Access Compliance Report

Public Rights-of-Way

Intersection ID: 13786	Main Street: E_7TH_ST	Cross Street: LAMAR_AV	Location: S
ADA ID: EFF9F8AB5B41	Ramp Type: Perp	Initial Pass/Fail: Fail	Overall Compliance: No
		Severity Score: 10

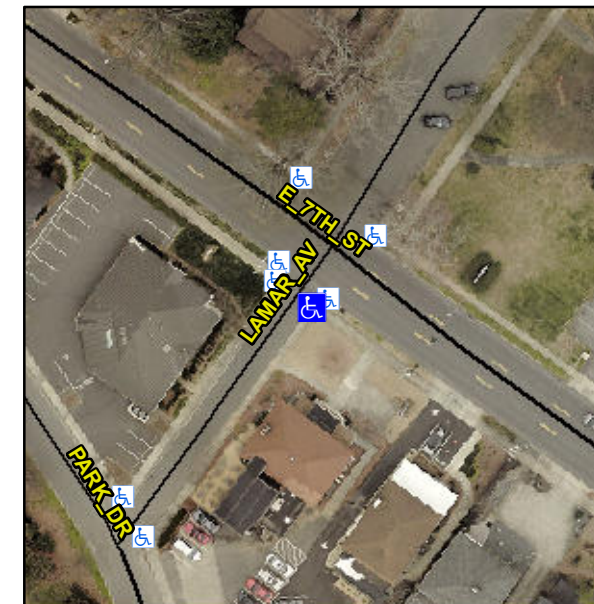
Not Found, R304.5.1, R304.5.3

Compliance	Description	Data	Compliance	Description	Data
N/A	Ramp Length (in)	24.0	Yes	Ramp Slope (%)	6.5
No	Ramp Width (in)	45.0	No	Ramp XSlope (%)	4.1
N/A	Flare Type LT	N/A	N/A	Flare Type RT	N/A
N/A	Flare Slope LT (%)	N/A	N/A	Flare Slope RT (%)	N/A
N/A	Flare Traversable LT?	N/A	N/A	Flare Traversable RT?	N/A
N/A	Landing Length (in)	N/A	N/A	DWS Provided?	N/A
N/A	Landing Width (in)	N/A	N/A	DWS Contrast?	N/A
N/A	Landing Slope (%)	N/A	N/A	DWS Length (in)	N/A
N/A	Landing X Slope (%)	N/A	N/A	DWS Full Width?	N/A
N/A	Landing Curb? (Y/N)	N/A	N/A	DWS Offset (in)	N/A
N/A	Shared Landing?	N/A			
N/A	Gutter Ponding?	N/A	N/A	Gutter Slope (%)	N/A
N/A	Gutter Lip Ht (in)	0.5	N/A	Gutter X Slope (%)	N/A
N/A	Painted X Walk1?	No	N/A	Painted X Walk2?	N/A
	X Walk 1 Direction	To NW		X Walk 2 Direction	N/A
N/A	X Walk 1 Width (in)	N/A	N/A	X Walk 2 Width (in)	N/A
	X Walk 1 Slope (%)	1.5		X Walk 2 Slope (%)	N/A
	X Walk 1 X Slope (%)	1.3		X Walk 2 X Slope (%)	N/A

Remove & Replace Entire Ramp.
